February 21, 2023

RE: Eagle Dam Removal Project – Potential Effects on Town Water Supply Sources

Review of CL&WE Report and Presentation

Figure 1
Existing Well 2 and Well 3 Zone I Areas

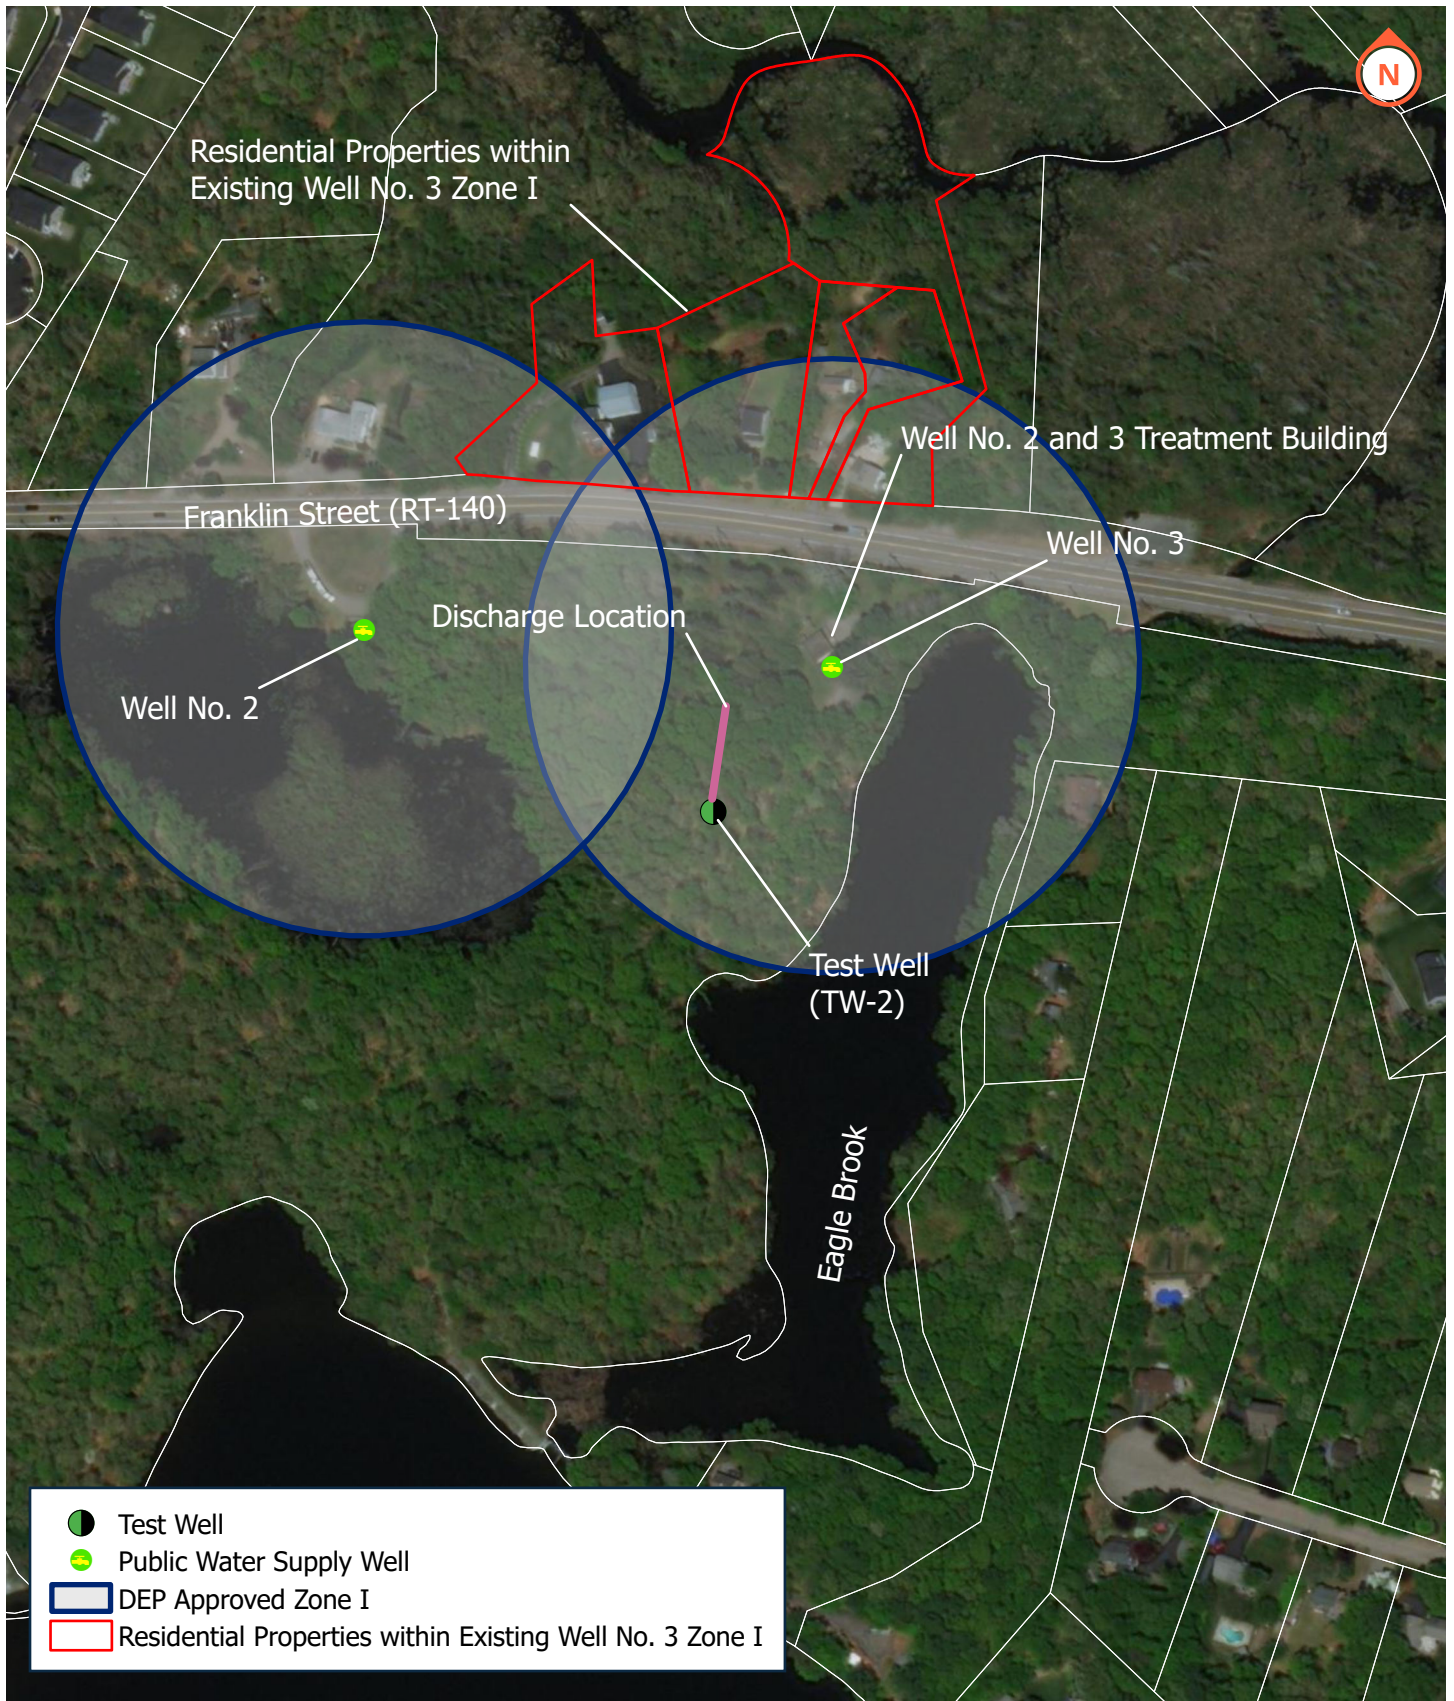
In their report, CL&WE implies that removing of the Eagle Dam will significantly impact the water supply capacity because the Zone I area and most of the Zone II (IWPA) overlaps the Old Mill Pond. As stated in the definitions above, the Zone I area is a protective radius around the well and the water supplier should own or control all property within the 400-foot radius established for wells yielding greater than 100,000 gpd. Figure 1 presents the extent of the Zone I area for both Well 2 and Well 3. CL&WE's reference and calculations regarding the Zone II/IWPA impact is misleading. The

IWPA is not applicable to Well 2 and Well 3, because the Town has a delineated Zone II. The Zone II and not the IWPA delineates the area of the aquifer that contributes water to Well 2 and Well 3.

Figure 2 - Wrentham Well #2 and #3 Zone II

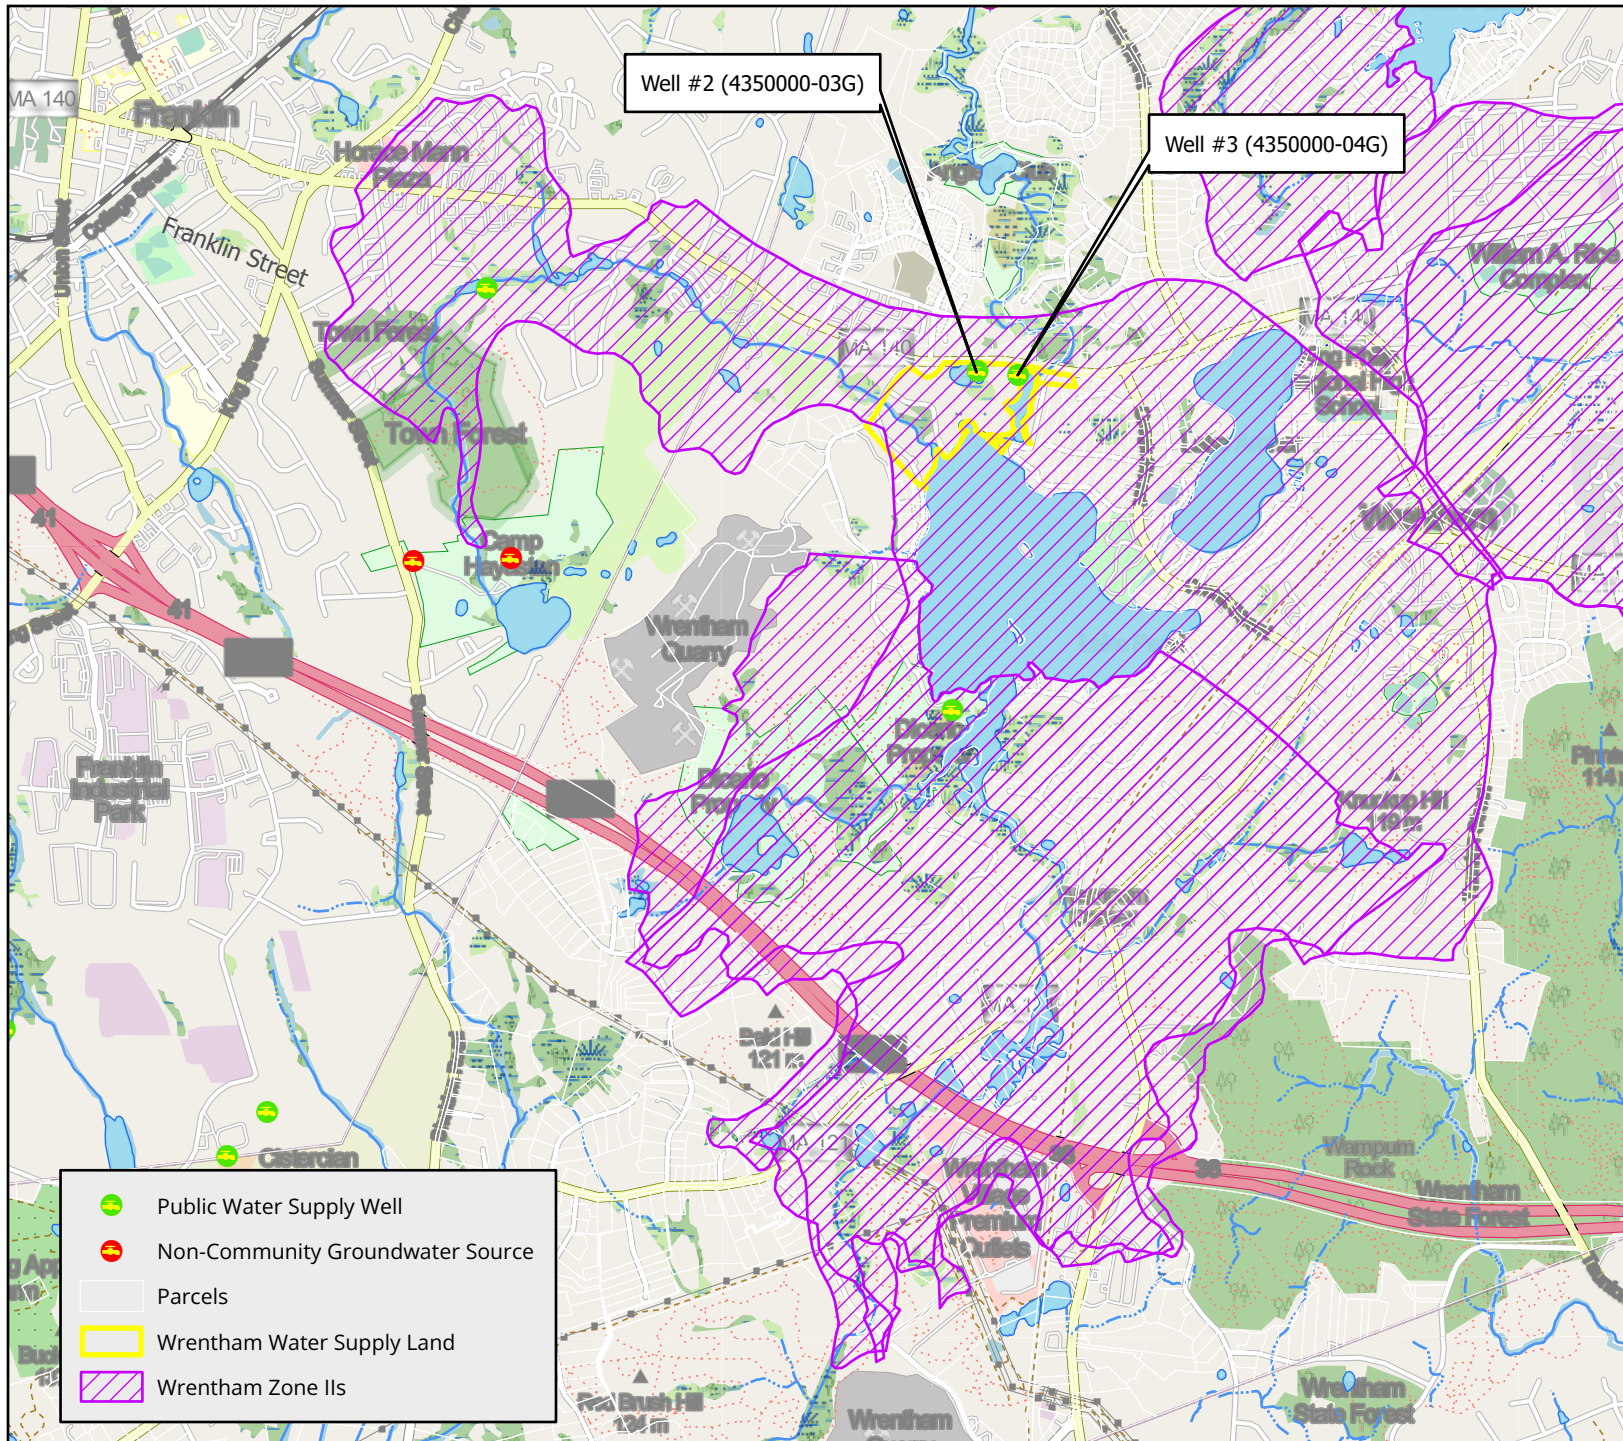
While CL&WE suggests that the Zone I/IWPA areas and the Old Mill Pond provide a significant volume of water to Wells 1 and 2, the Zone II delineations encompass a much larger area, and defines the area of aquifer that contributes water to these wells. Figure 2 shows the approximate extent of the Zone II area for Wells 2 and 3 and shows that the area of contribution to the Town's main groundwater supply sources extends far beyond the Zone I areas.

Figure 3
Well 3R (TW-2) Zone I Area

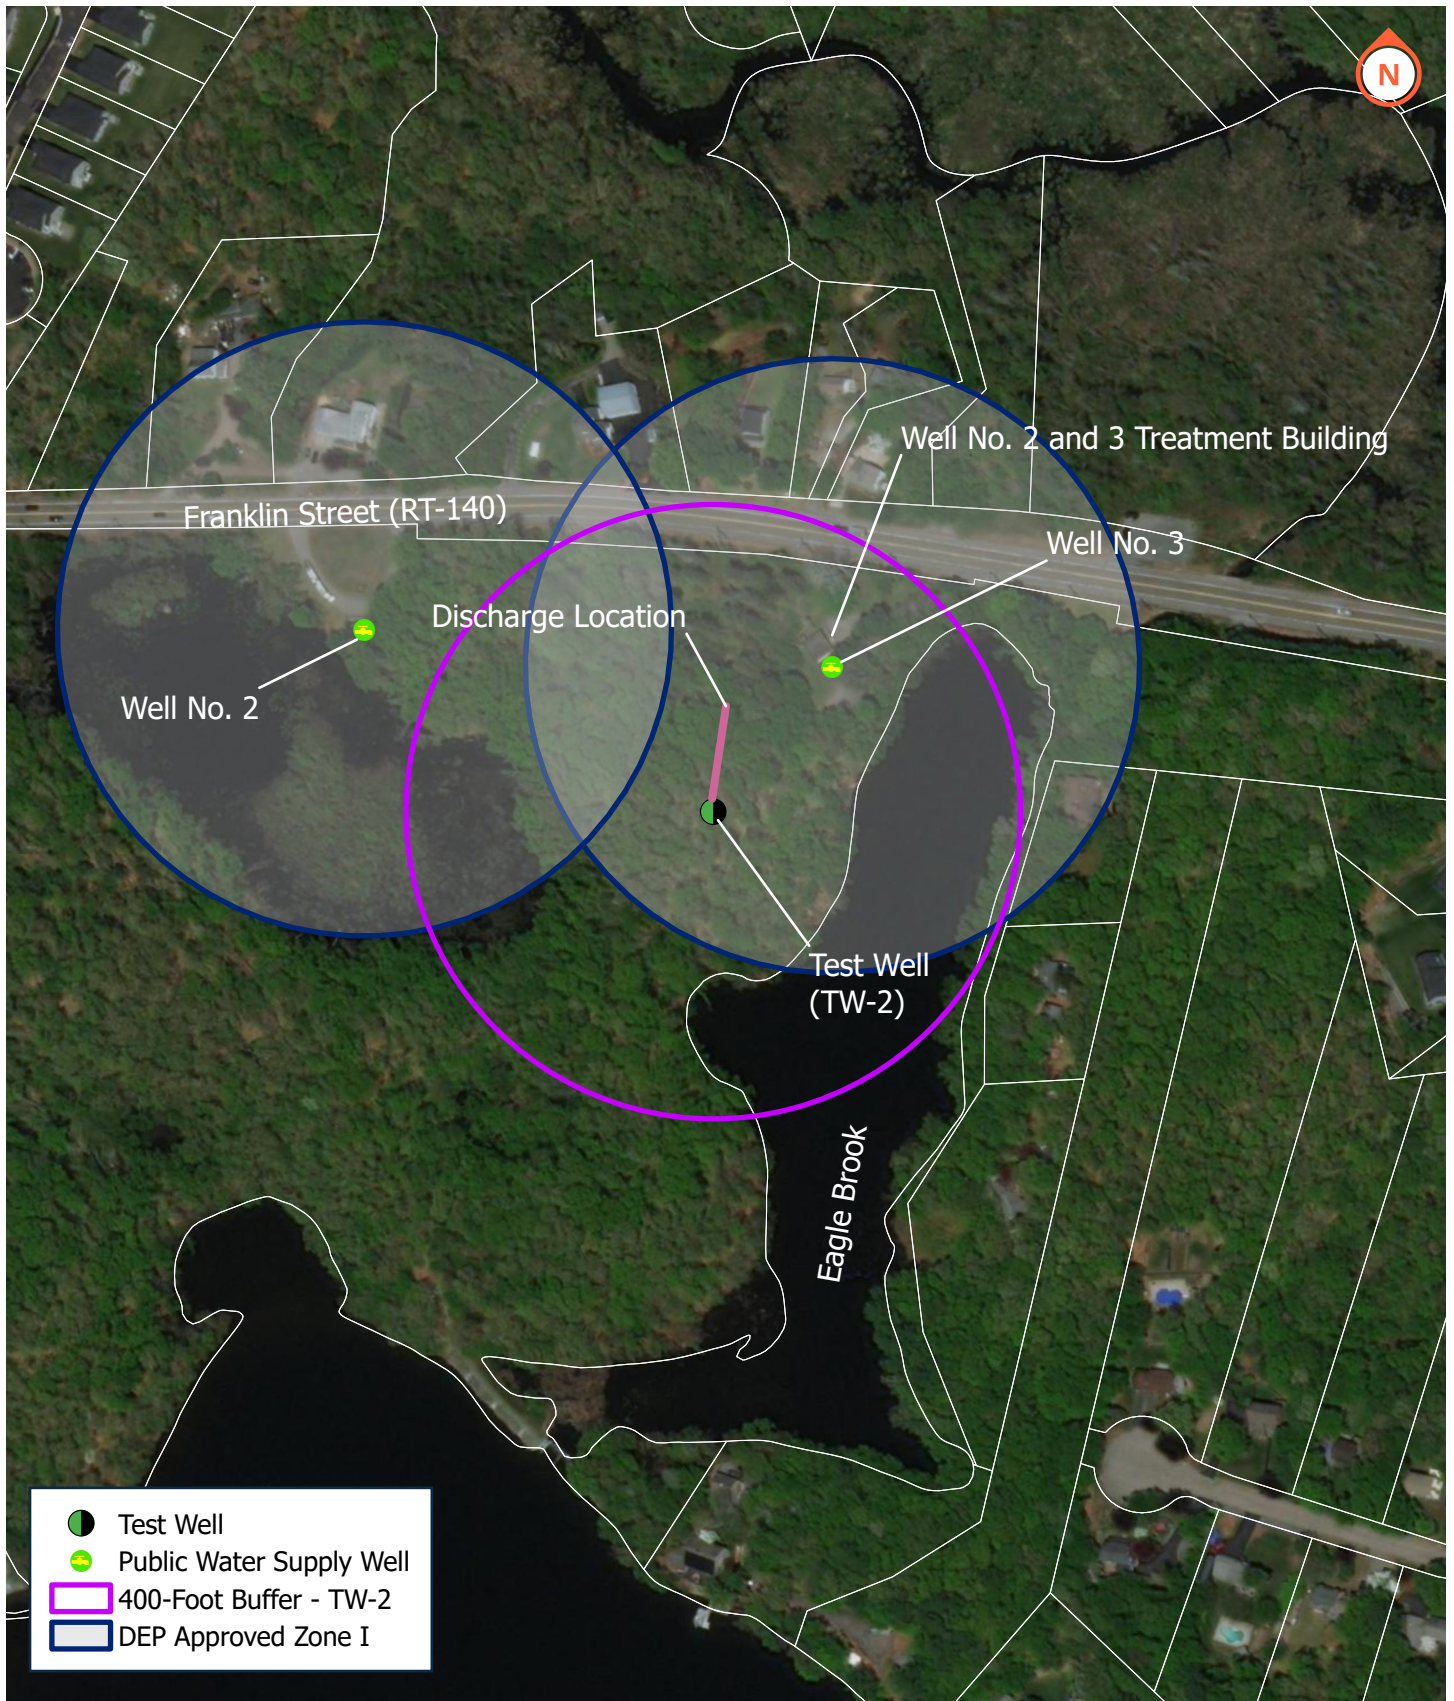
Figure 3 shows Well 3 and the location of the proposed replacement well while also depicting the 400-foot Zone I radius for the proposed replacement well. The 400-foot Zone I for the replacement well complies with Zone I requirements except for Route 140, which a portion of the road remains within the Zone I. While a public roadway is not a consistent land use for public water supply protection, the proposed replacement well location allows for greater ownership and control of the Zone I. Property within the Zone I to the south of Route 140, with the exception of Old Mill Pond, is owned by the Town and is exclusively for public water supply protection.

EP contacted Ms. Michelle Regon with the MassDEP Southeast Region Office (SERO) Drinking Water program regarding permitting a replacement well for Well 3. The proposed replacement well will be located further from Route 140 than the existing production well and remove residential properties within the existing Well 3 Zone I. Eagle Brook and Old Mill Pond are located within the Zone I to the east of the existing Well 3 and proposed replacement well locations. Ms. Regon confirmed that this surface water feature is a compliant land use within the Zone I for water supply protection.
